Environmental Control and Protection - Planning Consultation Response

Planning Application Reference:	20/03641/OUT
Environmental Health Reference:	WK/202010891
Description of Proposal:	
Address:	Land South Of White Horse Business Park, Windsor Road, White Horse Business Park, Trowbridge, Wiltshire
Site Visited:	Yes

I am writing following amended plans submitted 28.01.2022. The amended plans include a noise impact assessment and the air quality assessment has been resubmitted.

Figure 6-2
Predicted Night-time $L_{Aeq,8hr}$ dB Sound Levels Across the Proposed Development

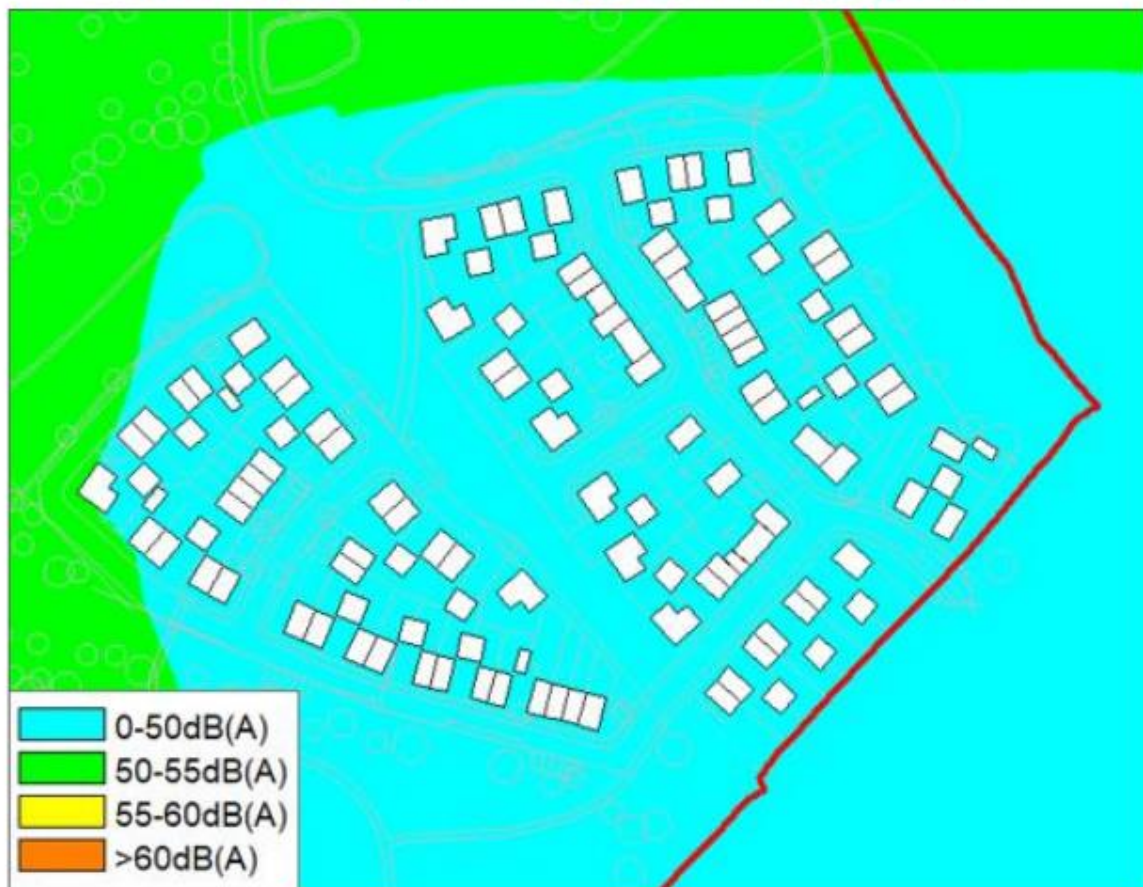
In regards to night time sound levels, figure 6.2 (see below) shows the majority of the site will have external noise levels of between 0 and 50dB $L_{Aeq8hrs}$ with the building at the eastern extreme between 50 and 55dB $L_{Aeq8hrs}$. I'm afraid this is not very helpful information. The target for bedrooms at night is 30dB $L_{Aeq8hrs}$, with an open window the 50dB $L_{Aeq8hrs}$ will be brought down to 35dB. If the whole site will have bedrooms at 35dB $L_{Aeq8hrs}$ or higher with windows open, this is not acceptable. We need to see more specific data so we can see how many facades will achieve 30dB in bedrooms at night with windows open and how many will have to have windows closed to achieve the recommended level. Site and internal layout can be used to minimise the number of dwellings that will be above the target level with windows open. We would then be able to make a judgment on the acceptability of the proposals.

Figure 6-3
Predicted L_{Amax} dB Sound Levels Across the Proposed Development

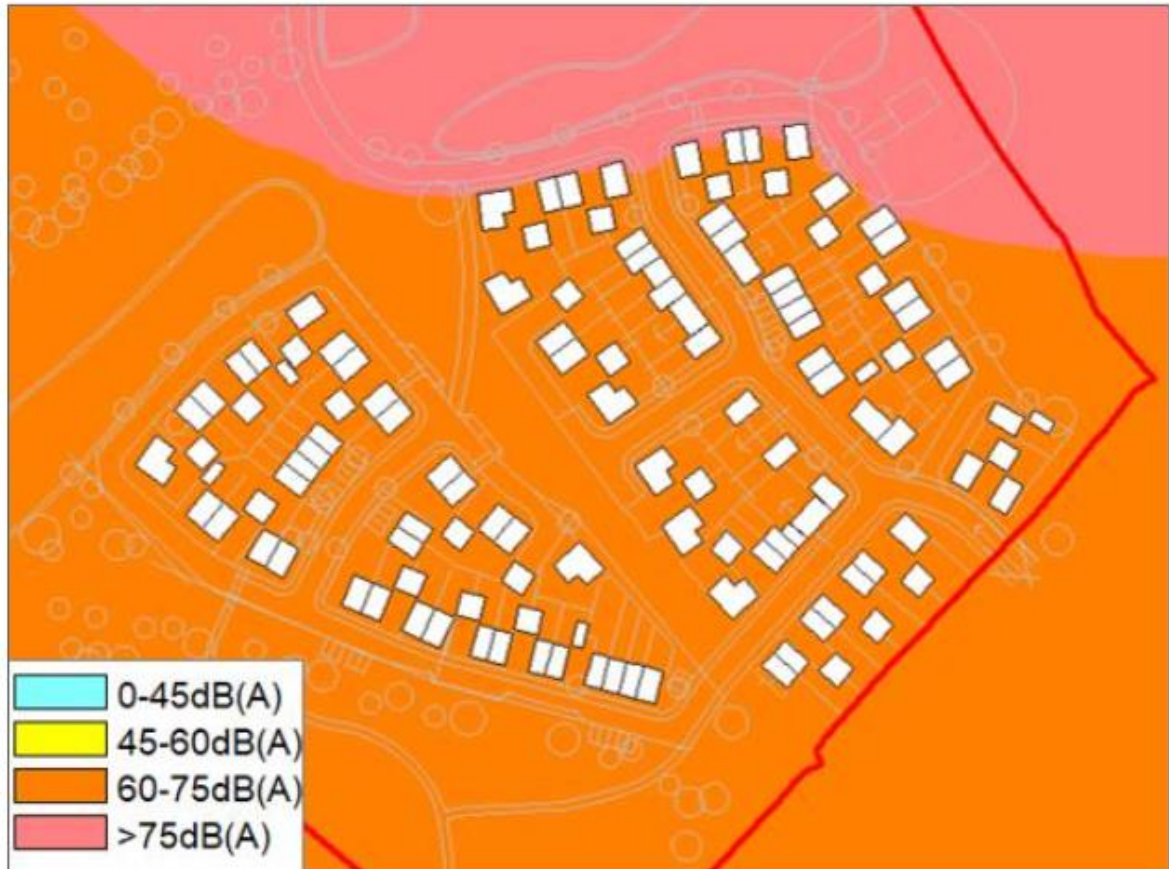
It is a similar situation with the L_{Amax} noise levels shown in figure 6-3 (see below). Almost the whole site is shown to be subject to noise levels of between 60dB and 75dB L_{Amax} . Residents would therefore need to keep windows closed for suitable internal noise levels to be achieved. This would not be acceptable. 60dB L_{Amax} could be brought down to 45dB L_{Amax} with an open window, which is the target, but anything above 60dB L_{Amax} will exceed the target. We need to see more detailed predictions of L_{Amax} noise levels. The number of incidents of peak noise levels which are above the target is also important in this. The WHO Guidelines on Community Noise set out how exceeding the target of 45dB L_{Amax} more than 10-15 times a night will affect sleep.
